**Resiliency Subworkgroup
Pretlow Anchor Branch Norfolk Public Library
111 W. Oceanview Ave, Norfolk, VA
March 10, 2020**

Summary

FIGURE R301.2(8)
COMPONENT AND CLADDING PRESSURE ZONES

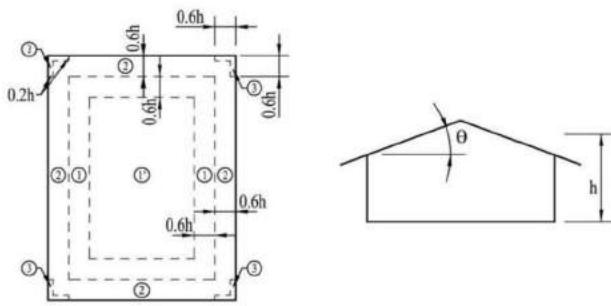
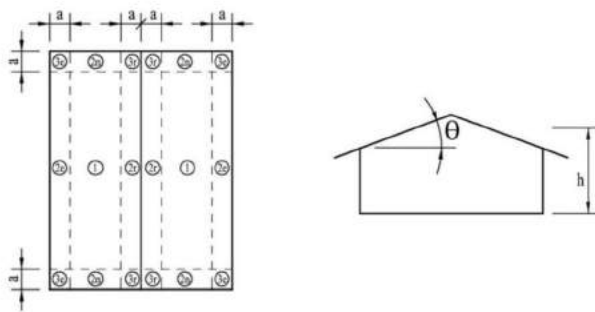
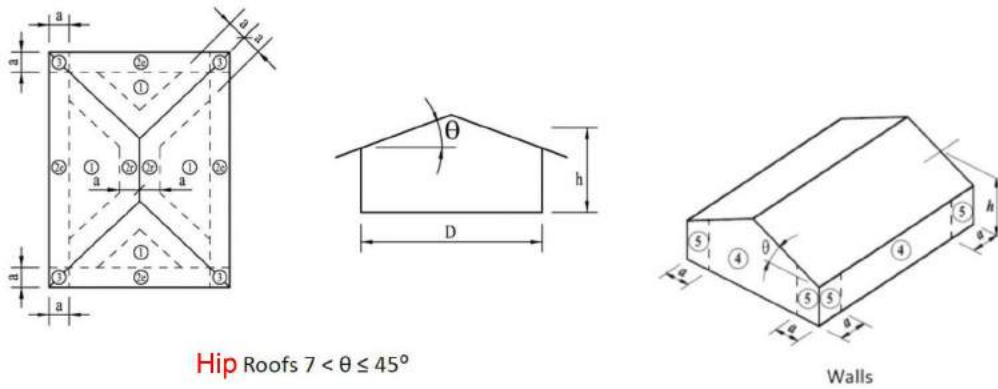
The simplified component and cladding loads in Table R301.2(2) are proposed to be revised for correlation with the new roof component and cladding loads for buildings with mean roof heights less than or equal to 60 feet. The roof zones and pressure coefficients in ASCE 7-16 Figure 30.4-2 (which includes Figures 30.4-2A through

30.4-2I) have been revised based on an analysis of an extensive wind tunnel database. All source data used in the study are publically accessible through the National Institute of Standards and Technology (NIST) website. Compared to previous versions of ASCE 7, the pressure coefficients have been increased, and are now more consistent with coefficients for buildings higher than 60 feet. Roof zones sizes are also modified from those of earlier versions in order to minimize the increase of pressure coefficients in Zones 1 and 2. The data indicate that for these low-rise buildings, the size of the roof zones depend primarily on the building height, h . The G_{Cp} values given in ASCE 7-16 Figures 30.4-2A through 30.4-2I are associated with wind tunnel tests performed in both Exposure B and C. For ASCE 7-16 Figure 30.4-2A, the coefficients apply equally to Exposure B and C, based on wind tunnel data that show insignificant difference in (G_{Cp}) for Exposure B and C. Consequently, the truncation for K_z in Table 30.3-1 of ASCE 7-10 is not required for building below 30 feet, and the lower K_z values may be used as shown revised in Figure R301.2(3) of the IRC. More explanation is found in the Commentary to ASCE 7-16 Chapter 30 (attached to this proposal).

Figure R704.2.1 Typical single span vinyl soffit panel support

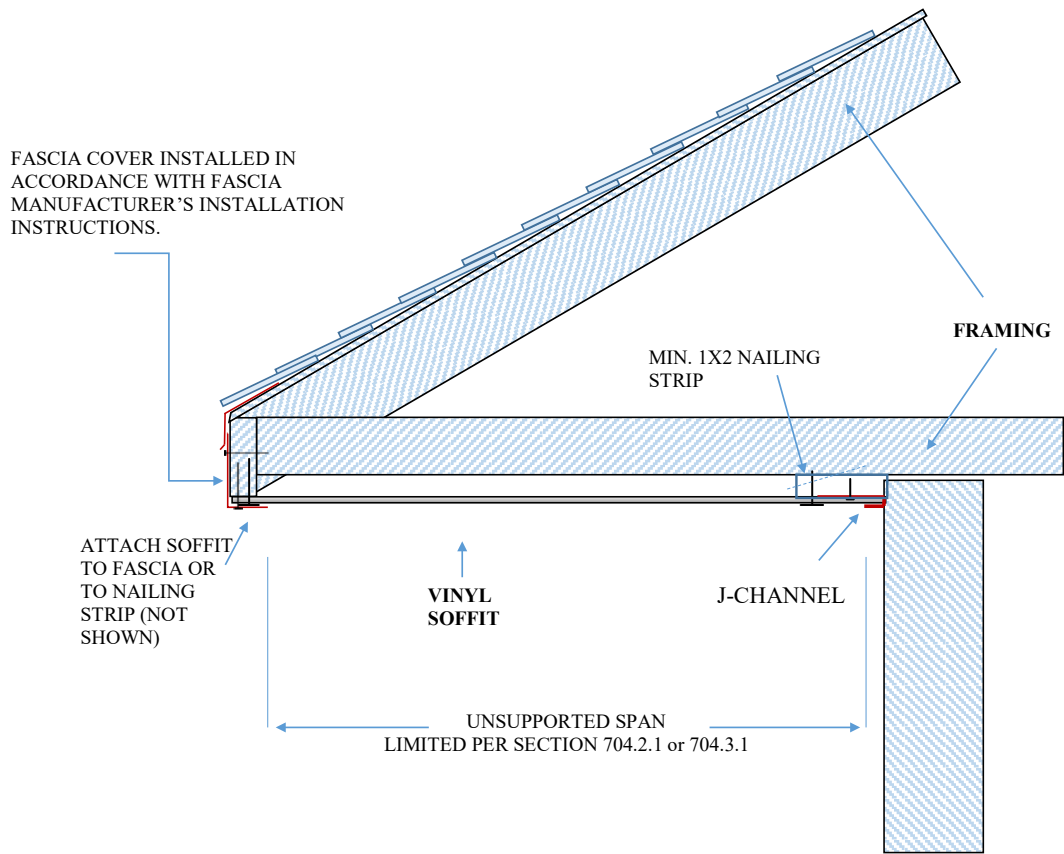
R704.2.1 Vinyl soffit panels. Vinyl soffit panels shall be installed using fasteners specified by the manufacturer and shall be fastened at both ends to a supporting component such as a nailing strip, fascia or subfascia component in accordance with Figure R704.2.1. Where the unsupported span of soffit panels is greater than 16 inches, intermediate nailing strips shall be provided in accordance with Figure R704.2.2. Vinyl soffit panels shall be installed in accordance with the manufacturer's installation instructions. Fascia covers shall be installed in accordance with the manufacturer's installation instructions.

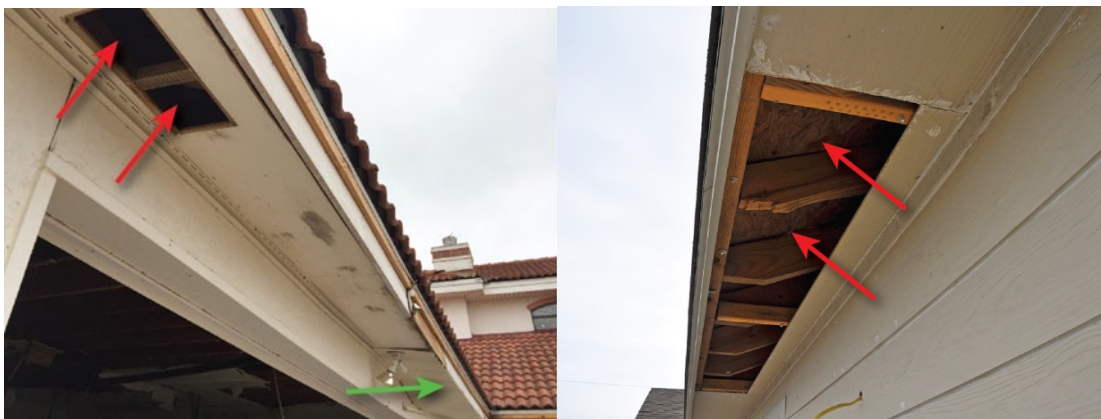
In many cases, inadequate support and attachment at the ends of the soffit panel led to failure of the soffit. The Sugarloaf Key house shown below (FL MAT Report Figure 4-19) lost its vinyl soffit in several areas. The red oval shows where the soffit panel was stripped from the assembly's J-channel, which remains attached along the exterior wall (yellow arrows). The soffit appears to have been fastened to only a single nailing strip across the midpoint of the framing above. Section 704.2.1 (including Figure 704.2.1) of the proposal has been included to clarify that vinyl soffit panels are required to be fastened at each end and the unsupported span cannot exceed specified limits (16 or 12 inches) unless permitted by the manufacturer's product approval.

In some cases, vinyl soffit failure appeared to have been associated with fascia cover loss as shown in the image below from Little Torch Key (FL MAT Report Figure 4-18). Loss of the fascia cover likely increases wind pressures on vinyl soffit where the edges of the soffit are exposed.

The inset shows the remaining exposed soffit edge on the left side of the ridge (yellow outline) and missing vinyl soffit panels on the right side of the ridge (red outline).
